SAFETY RECALL BULLETIN

SUBJECT: Hood Restraint Cylinder

**SAFETY RECALL RVXX0704
OCTOBER 2007**

T8009384

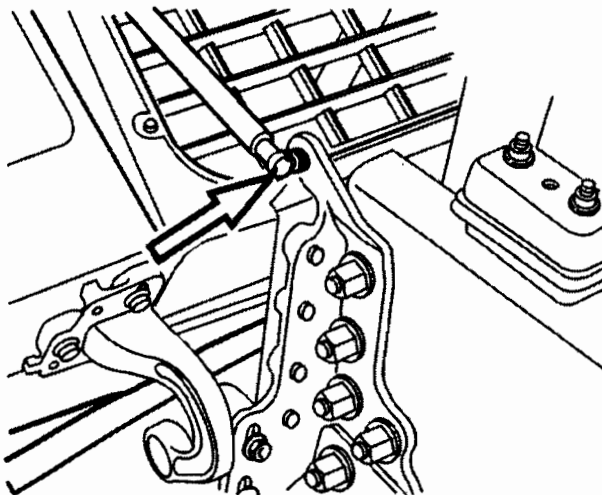
Remove the cylinder the chassis bracket.

T8009462

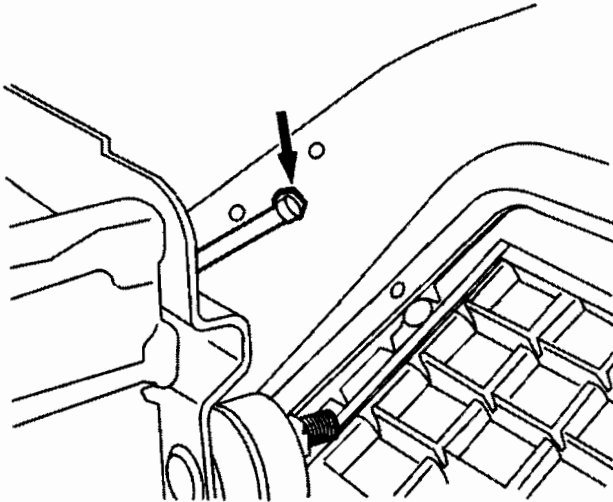
Remove the cylinder from the hood. **IMPORTANT NOTE: DO NOT REMOVE THE BALL STUD FROM THE HOOD ON VNM AND VNL MODELS!**

5. Attach the new cylinder (20725387) to the hood.
6. Install the new ball stud (20502948) and lock nut (971098) to the chassis bracket, and then attach the new cylinder (20725387) to the ball stud. Torque the ball stud to 48 ± 8 Nm (35 ± 6 ft-lb).

T8009384

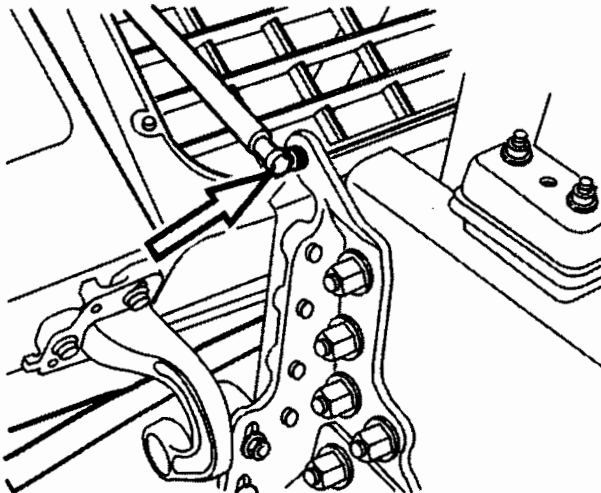
Remove the cylinder and ball stud from the chassis bracket.

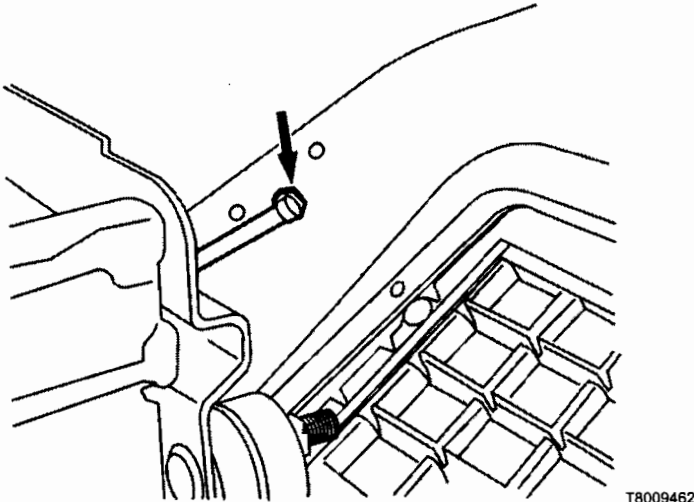
Remove the cylinder and ball stud from the hood.

5. Install the new ball stud (20502948) and washer (976945), and then attach the new cylinder (20725387) to the ball stud.
Torque the ball stud to 48 ± 8 Nm (35 ± 6 ft-lb).
6. Install the new ball stud (20502948) and lock nut (971098) to the chassis bracket, and then attach the new cylinder (20725387) to the ball stud. Torque the ball stud to 48 ± 8 Nm (35 ± 6 ft-lb).
